September 10, 2021

**SUBJECT: SIM Yard Charging Stations Project
CONTRACT NO. 071514**

ADDENDUM NUMBER # 02

1 CIVIL SITE PLAN - DEMOLITION
D2.0 SCALE: 1" = 20'-0"

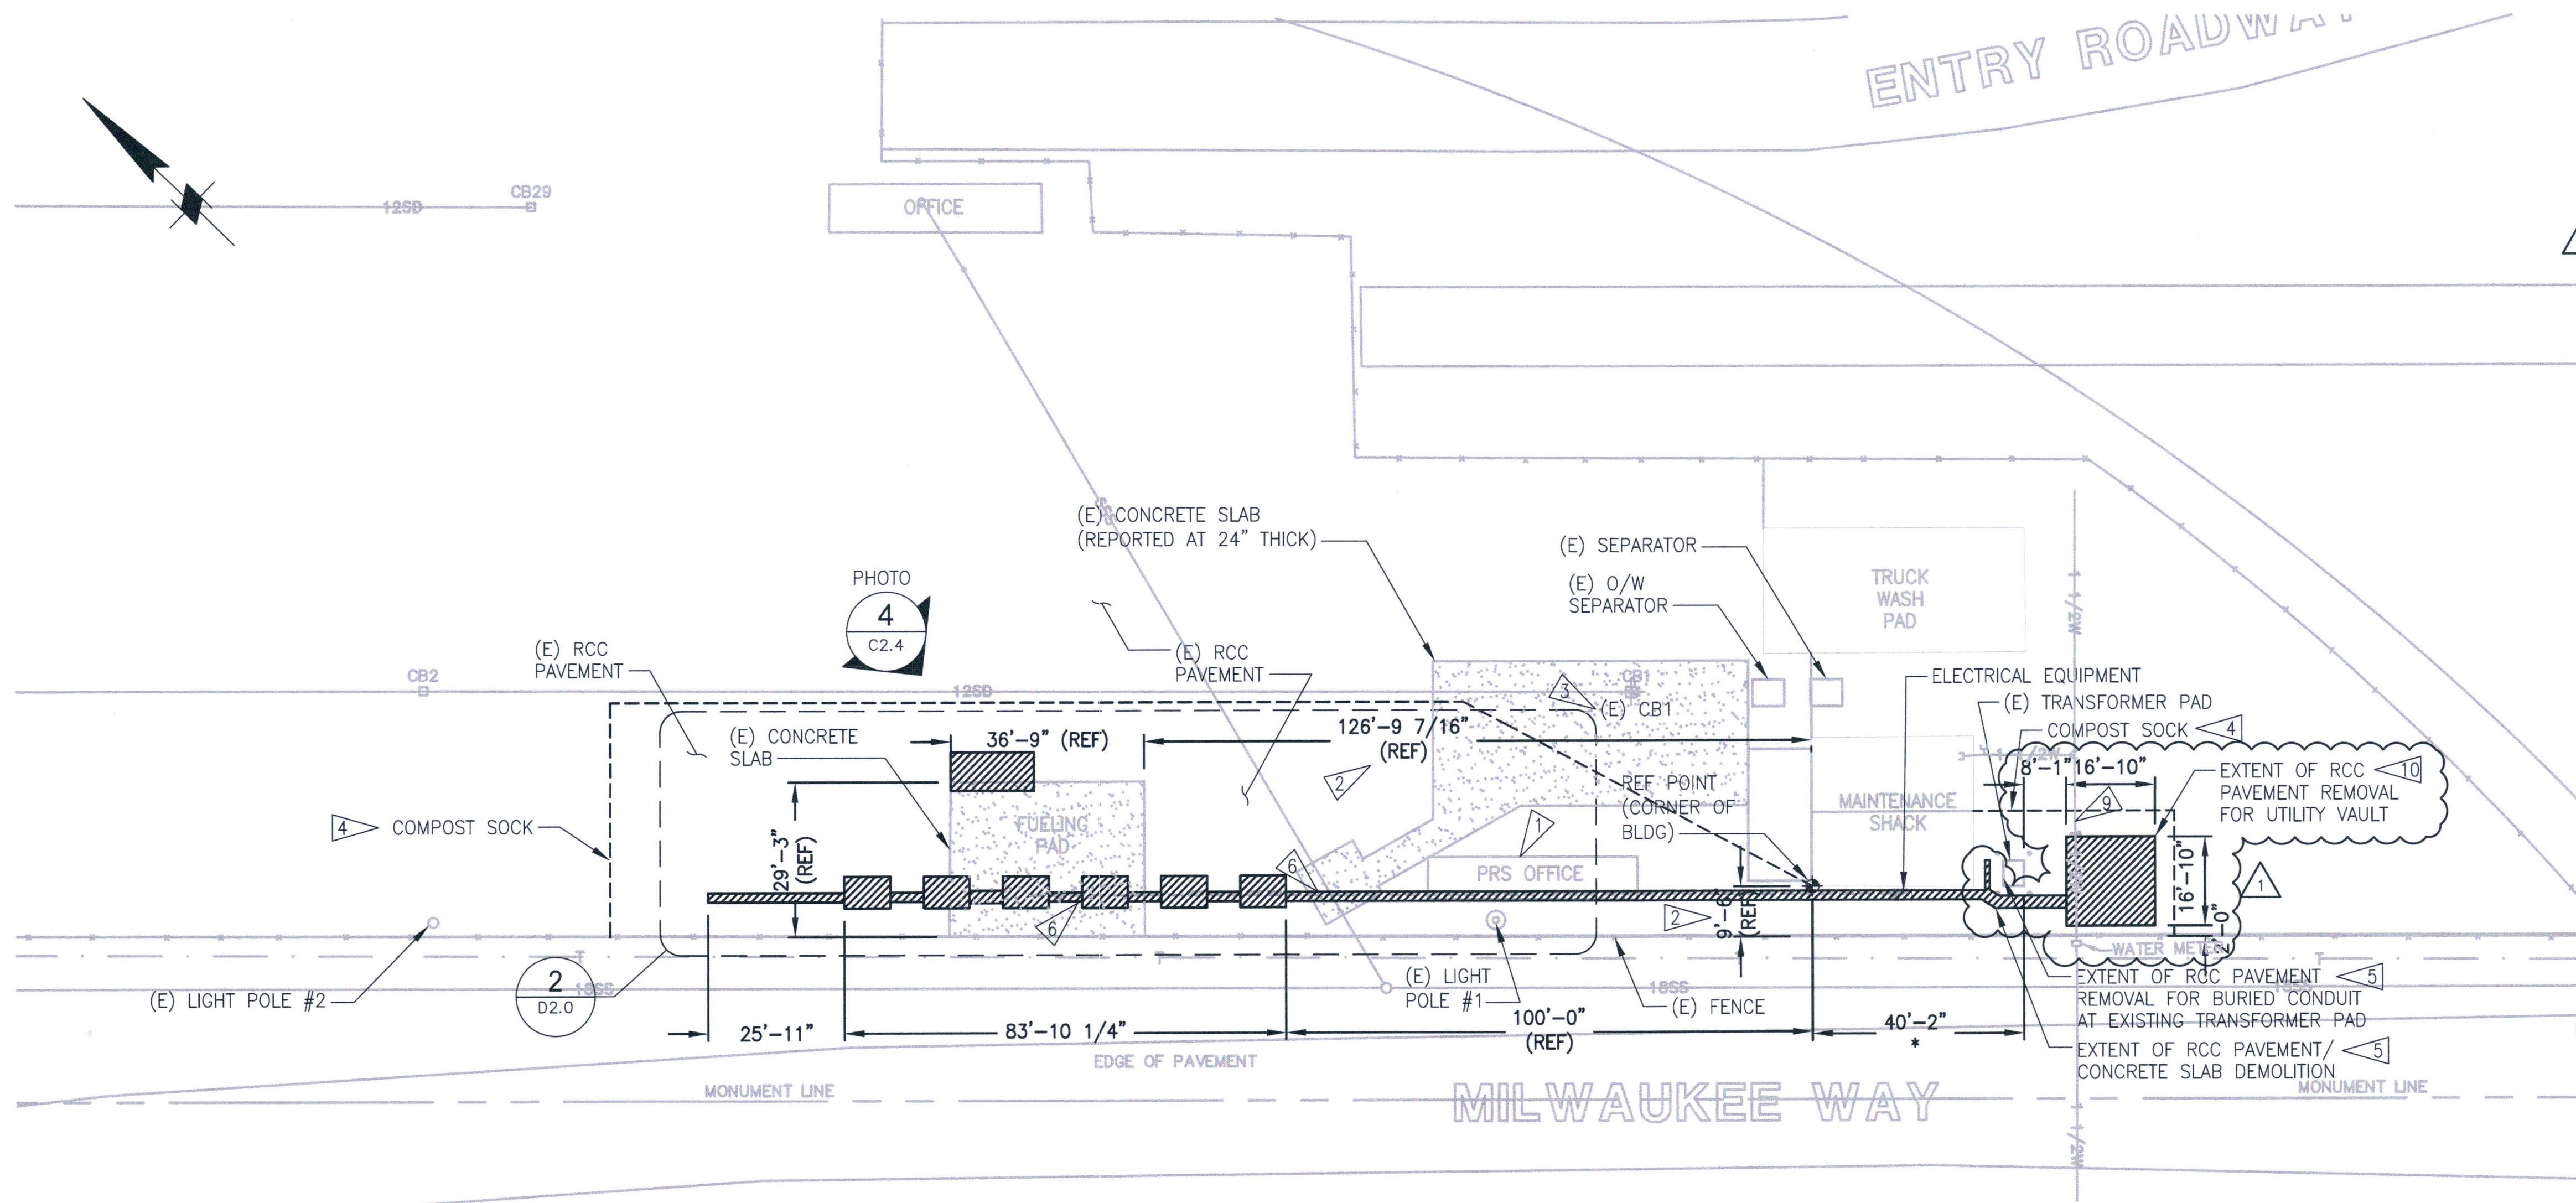
SHEET D2.0 – Civil Site Plan Demolition

- Revised Detail 1 to depict additional demolition in transformer area.
- Added contractor verification symbol to drawing Legend.
- Added Keyed Notes 9 & 10 with excavation requirements.

- EDGE OF EXCAVATION SHALL BE SLOPED AT 1:1. VAULT EXCAVATION PLAN DIMENSIONS PROVIDED MAY VARY DEPENDING ON FINAL EXCAVATION DEPTH. EXCAVATION DEPTH SHALL ALLOW FOR MINIMUM OF 9" OF 5/8" MINUS CRUSHED ROCK BELOW THE VAULT. CRUSHED ROCK SHALL EXTEND 12" BEYOND EDGE OF VAULT IN ALL DIRECTIONS. CONTRACTOR SHALL FOLLOW ALL VAULT INSTALLATION REQUIREMENTS OUTLINED IN TACOMA POWER STANDARD C-UG-1700.

1 CIVIL SITE PLAN
SCALE: 1" = 20'-0"

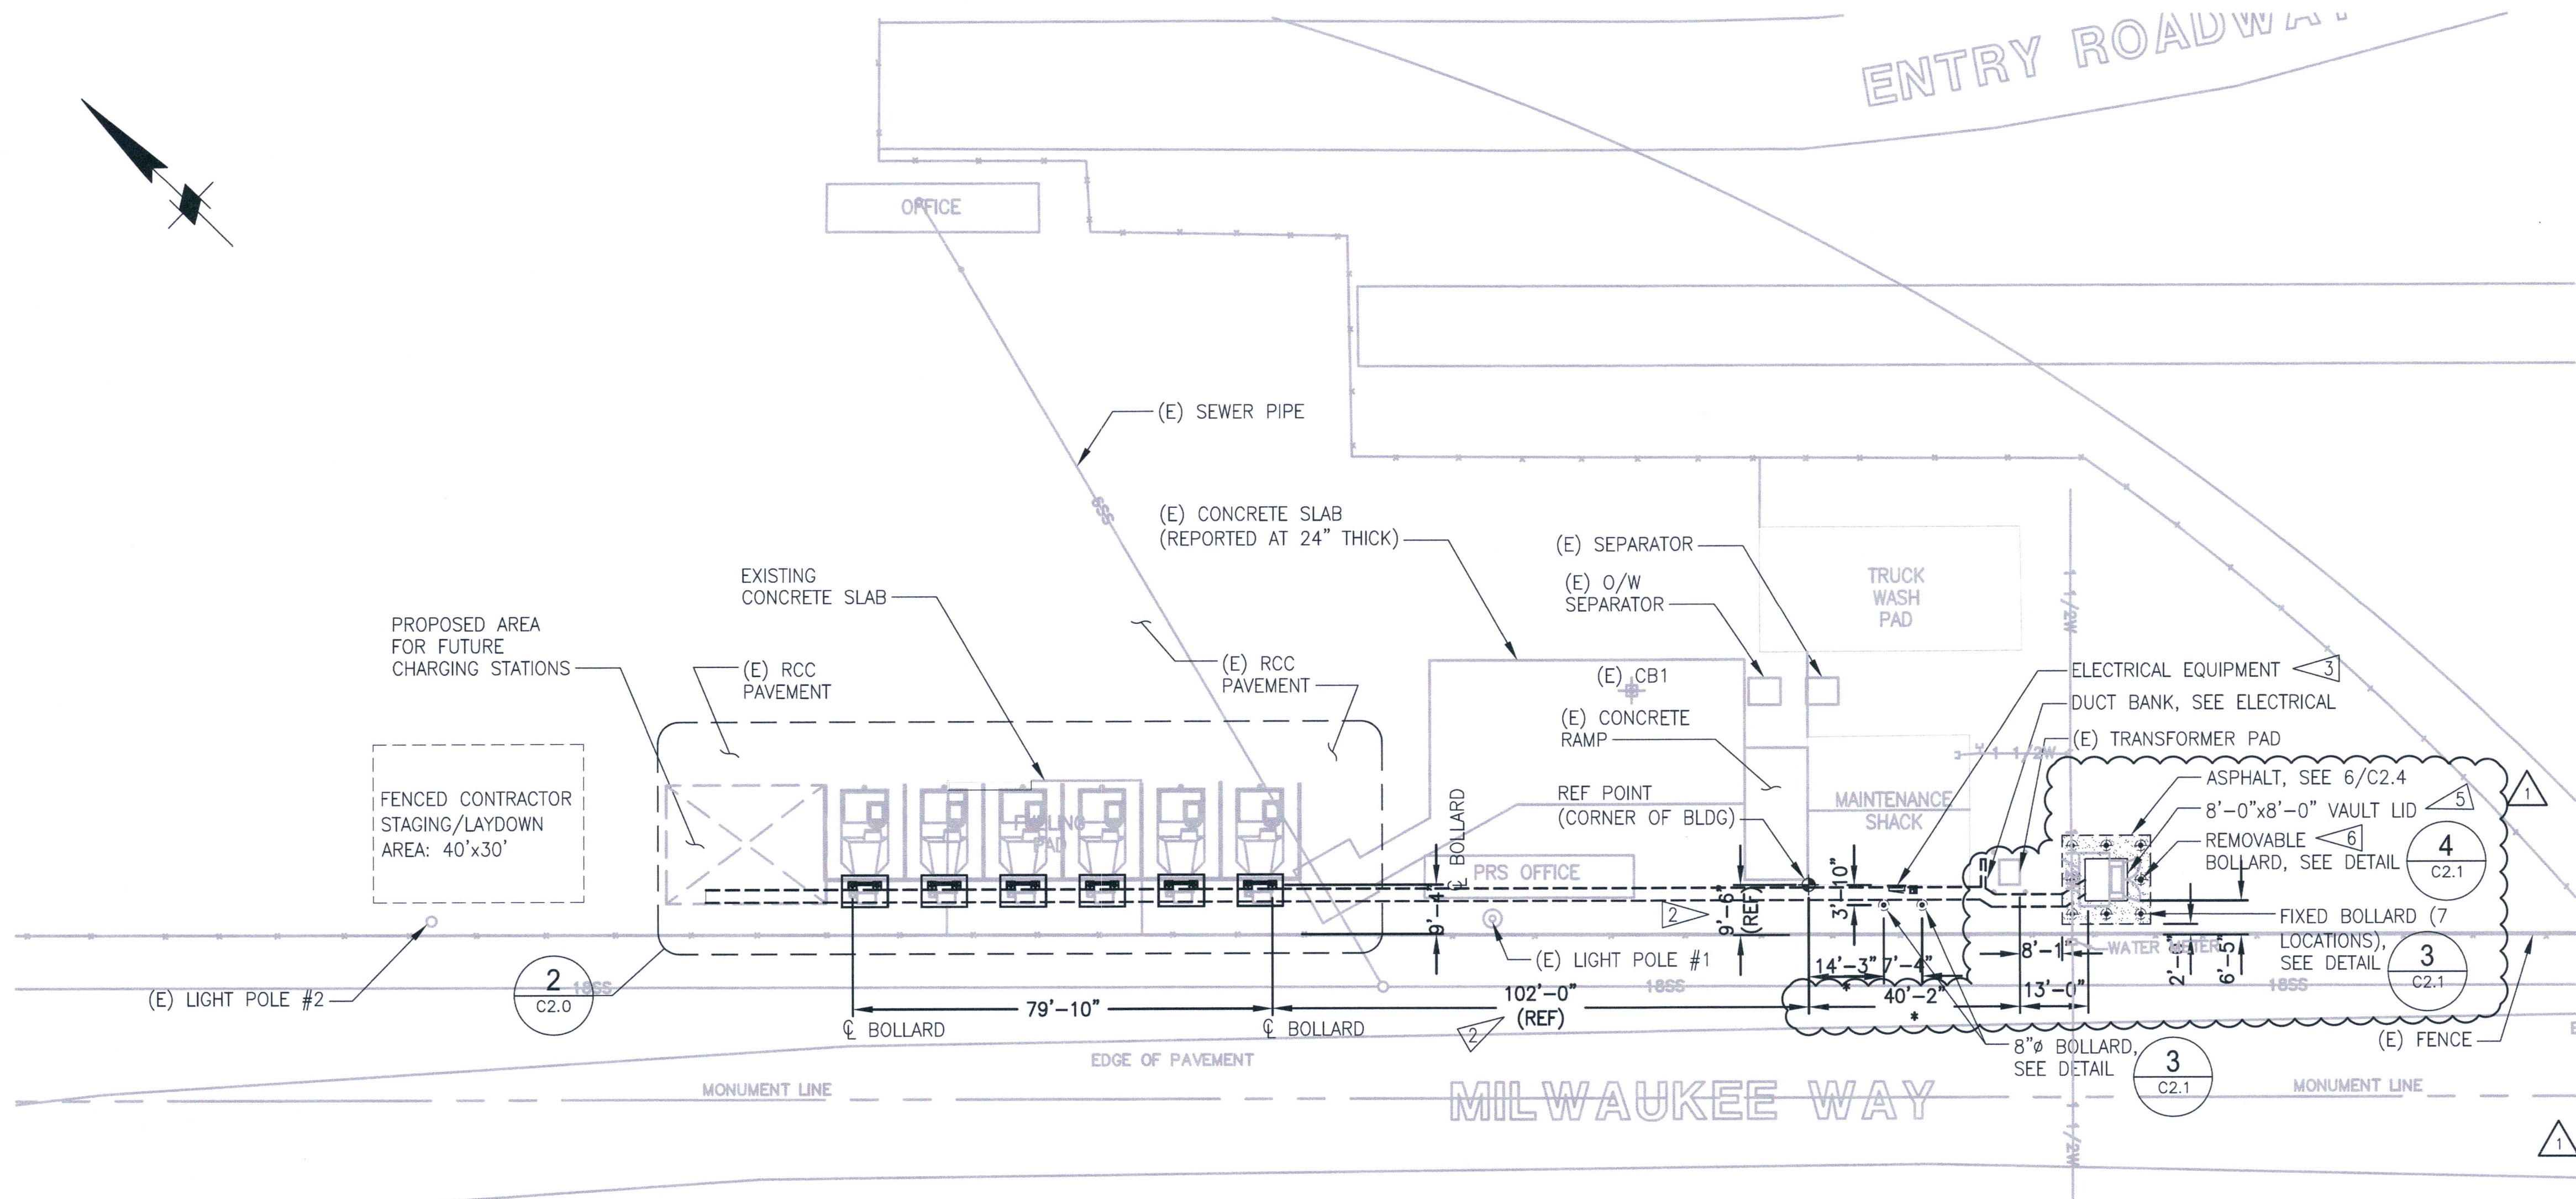
SHEET C2.0 – Civil Site Plan

- Revised Detail 1 to depict additional civil work in transformer area.
- Added Keyed Notes 5 & 6 with vault requirements, bollard requirements, and identification of applicable Tacoma Power standards.

- FOR MOUNTING DETAIL SEE DETAIL 1/C2.3.
- STRIPING WILL BE PROVIDED BY OTHERS, FOR PARKING STALL STRIPING SEE DETAIL 1/C2.4.
- PRECAST CONCRETE VAULT SHALL BE #774 TRANSFORMER/METER CABINET COVER #1 (TACOMA POWER MID#19461) PER TACOMA POWER STANDARD C-UG-2000 APPROVED VENDORS LIST. LID DIMENSIONS: 8'-0"x8'-0"x0'-8". VAULT DIMENSIONS: 7'-0"x7'-0"x3'-6".

- CONTRACTOR SHALL FOLLOW TACOMA POWER STANDARD C-UG-1700 FOR VAULT INSTALLATION INSTRUCTIONS. PROVIDE MINIMUM 9" OF COMPACTED 5/8" MINUS CRUSHED ROCK FOUNDATION BELOW VAULT. CRUSHED ROCK SHALL EXTEND 12" BEYOND VAULT EDGE ON ALL SIDES. SURROUNDING FINAL GRADE SHALL BE TO BOTTOM OF VAULT LID. BACKFILL WITH STRUCTURAL FILL IN 12" LIFTS, COMPACTING BETWEEN LIFTS.

- BOLLARDS SHALL BE PLACED PER TACOMA POWER STANDARD FOR GUARD POST INSTALLATION C-UG-1400 FOR A 500 KVA TRANSFORMER. 78" MAX CENTER TO CENTER SPACING AND 30" CENTER OF BOLLARD TO EDGE OF VAULT LID.

4
C2.0
REMOVABLE BOLLARD DETAIL
SCALE: 1 1/2" = 1'-0"

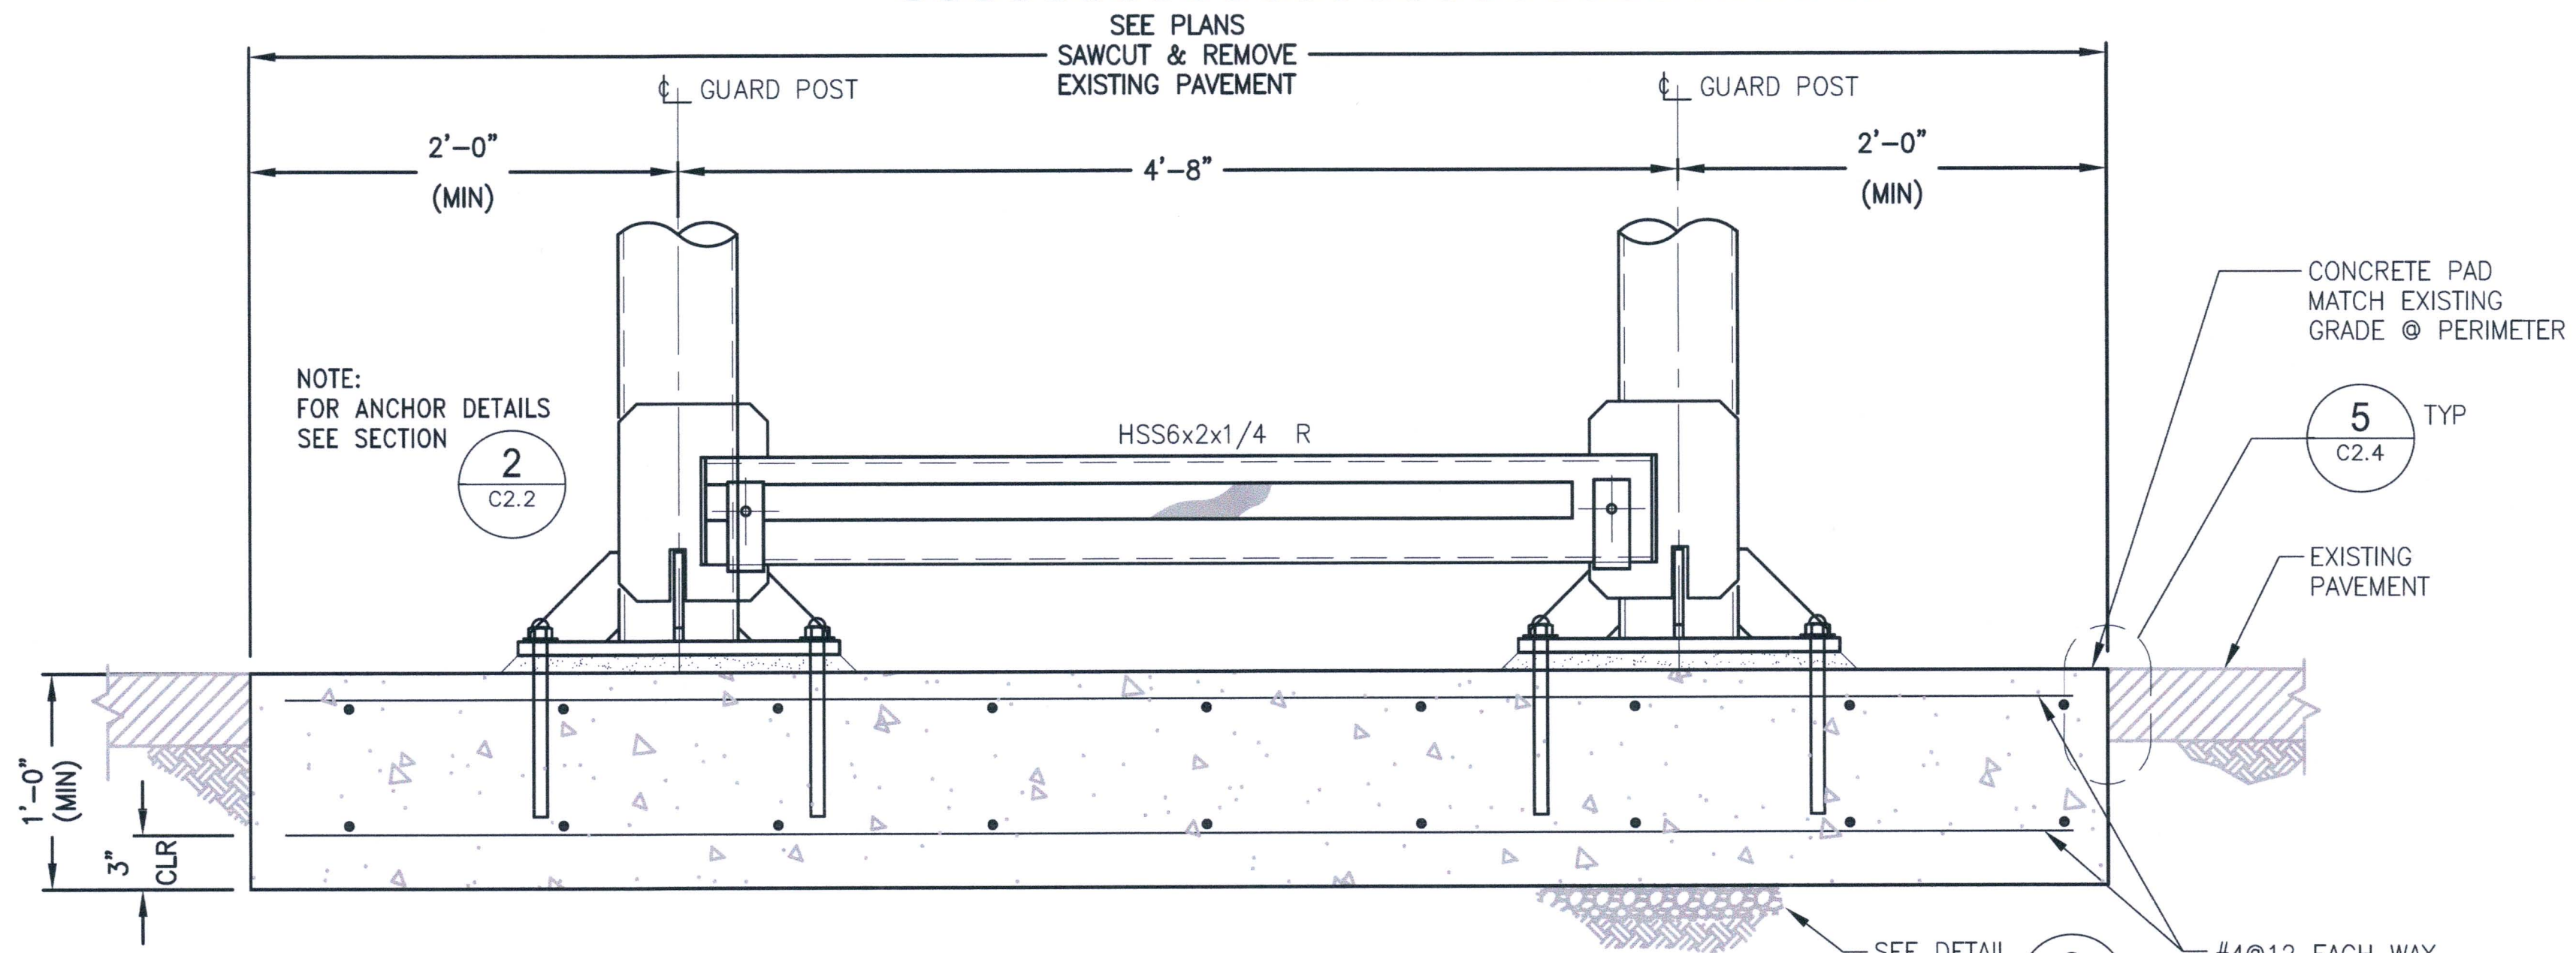
SHEET C2.1 – Structural Details

- Added Detail 4 to depict removable bollard design for new transformer area.
